Appln No. 10/679,820
Amdt date November 2, 2005
Reply to Office action of September 20, 2005

Amendments to the Drawings:

Attached are replacement and annotated sheets of amended FIGS. 1, 3, 6 and 7.

FIG. 1

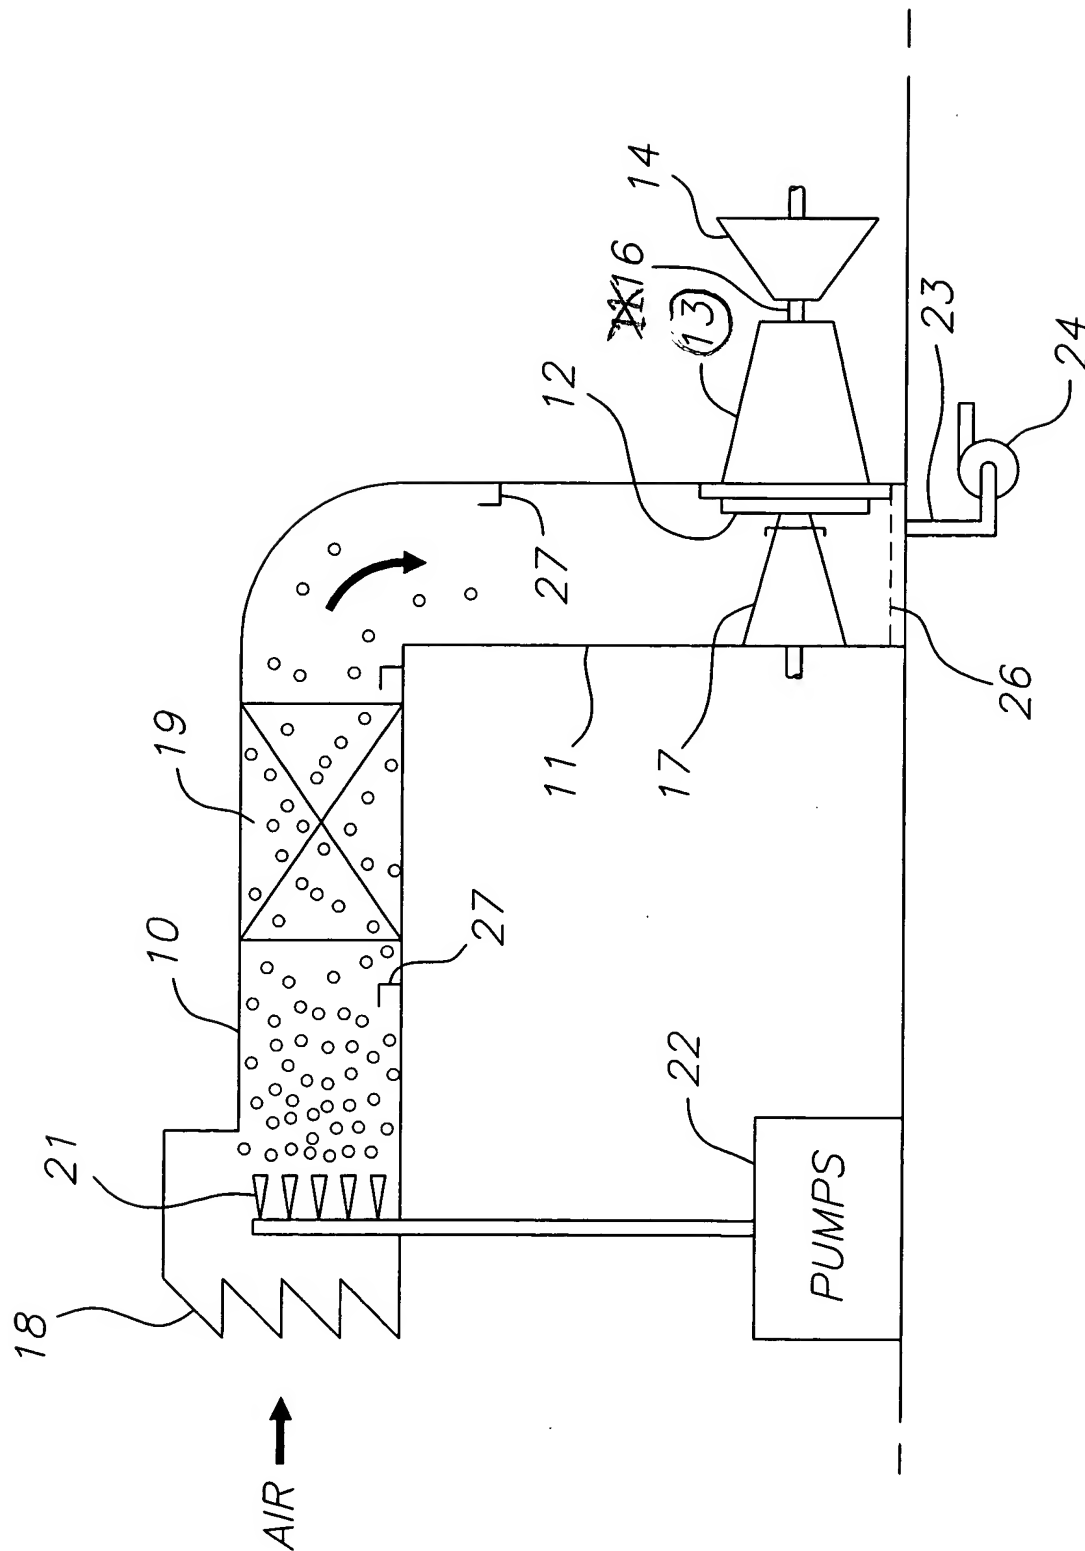
The objections to reference numerals 16, 33 and 34 in FIGS. 1 and 6 have been corrected.

FIG. 3

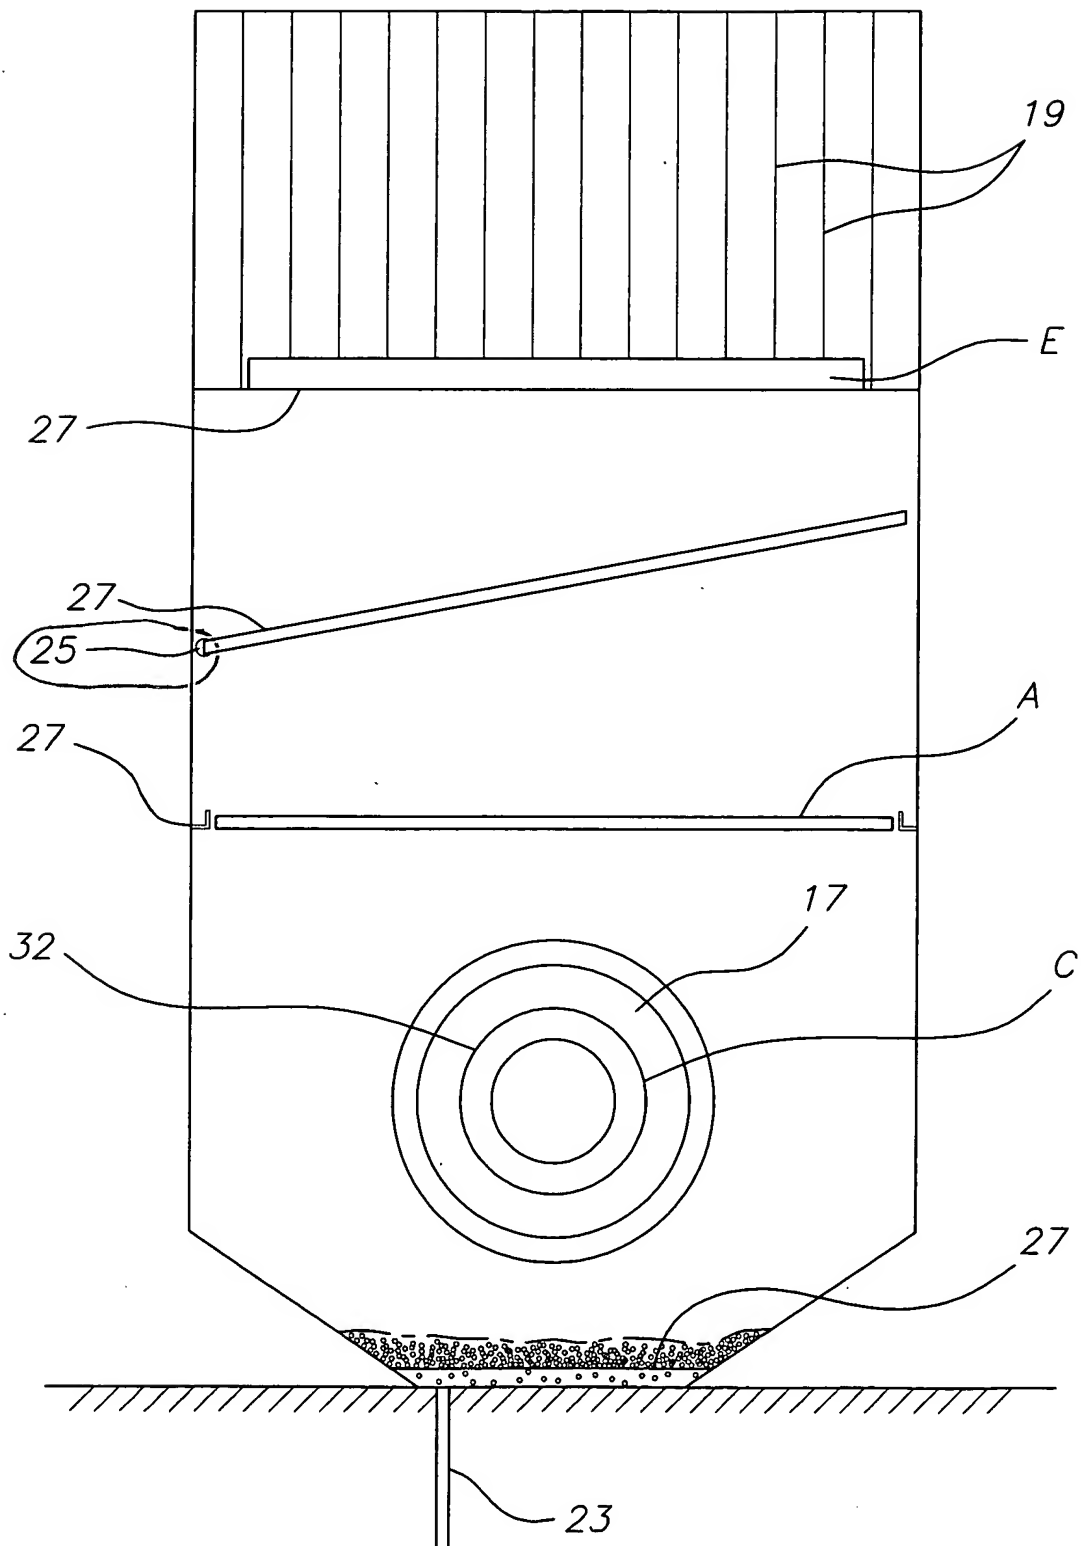
The Examiner alleges that a combination of a strip extending diagonally across the duct where a drain is near its downstream end (claims 5-8, and 18-20) is not illustrated in the drawings. A diagonal strip in a non-horizontal portion of the air duct is shown at 27 in FIG. 3, for example. A drain opening at the lower or downstream end of the strip, with a reference numeral 25 has been added to FIG. 3 and the reference numeral 25 added to the specification where that feature is mentioned. This objection is therefore no longer appropriate.

FIG. 7

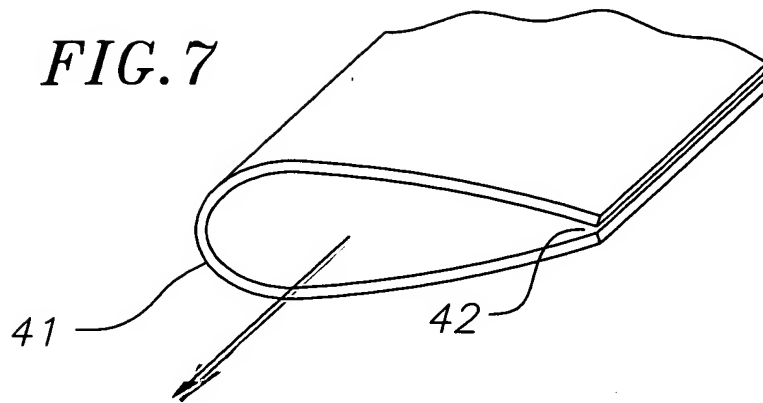
The Examiner objected that the drawings did not include vanes having a suction device (claim 27), and sucking water from a hollow strut (claim 37) or inlet guide vane (claim 39). Illustrating the verb "sucking" seems inappropriate, however, in an effort to respond to this objection an arrow indicating suction along the length of a vane, for example, has been added to FIG. 7. When this change is accepted, it is requested that this objection be withdrawn.
